Re: King II Mine
Pond Quarterly Inspection
3rd Quarter 2018

Re: King Coal II - Annual Water Quality Improvements Inspection (Amended)

Pic. 1 – Detention Pond outlet structure, dry.

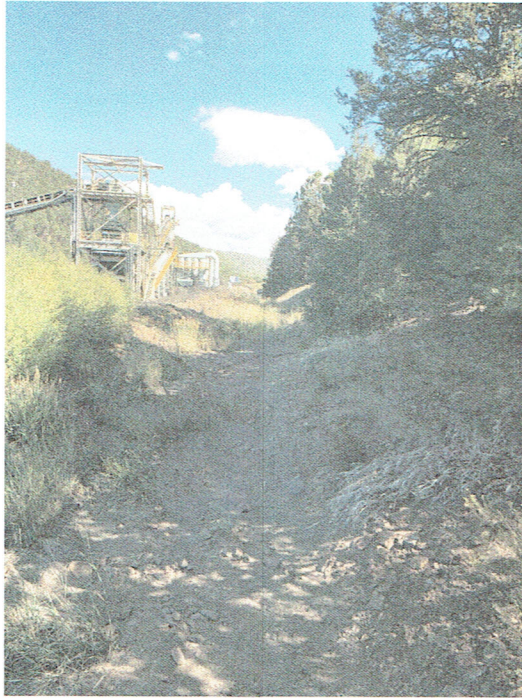
The vegetation established both inside and out of the pond is well established to minimize the erosion impacts of storm runoff. The outlet structure shows no signs of damage and was functioning as designed at the time of the inspection (see Pic. 1). The water quality pond appears to be in generally good condition. There were no signs of weakness or distress to either the outlet structure or the embankment material. The water quality pond has the storage capacity to function as designed.

Pic. 4 –Culvert inlet west of the loading/scale area west side of driveway.

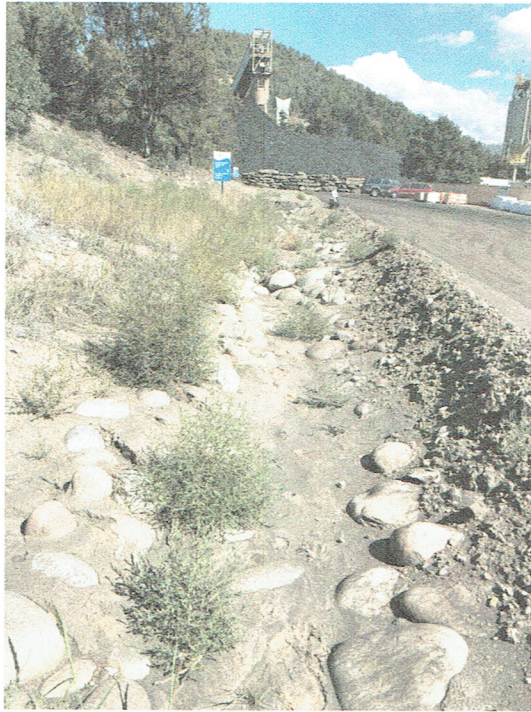
The culvert pipes on the site were in good condition overall. The treated water culvert located to the west of the truck loading/scale area (see Pic. 4) which runs under the driveway should be cleaned out to ensure excess runoff is not allowed to bypass the culvert and create erosion related issues downstream. The west clear water ditch at this location should also be cleaned out at this location. The lower ditch slope has resulted in sedimentation of the channel at this location (see Pic. 5).
